15. COA-086174-2021

3420 East Broad Street

STAFF REPORT

Construct new rear stairs and rooftop patio, enlarge basement windows, and install solar panels.

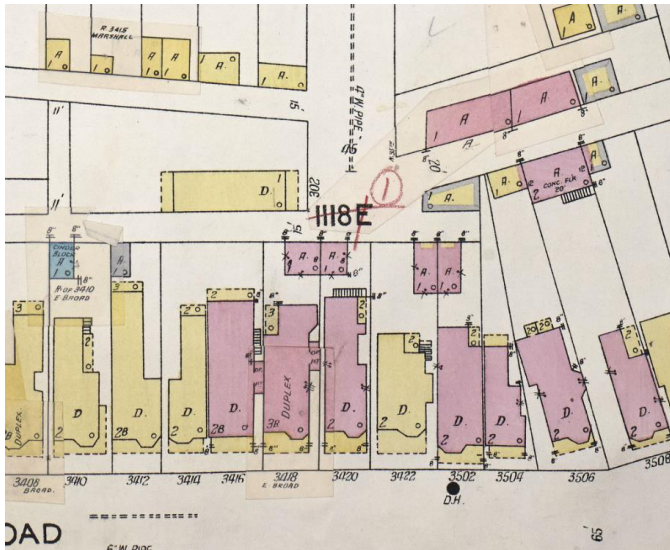
The applicant proposes to install solar panels on the rear roof slope. Staff finds this is a

visible from the public right-of-way.

minimally visible location and recommends approval with the condition that the roof slope remain intact.
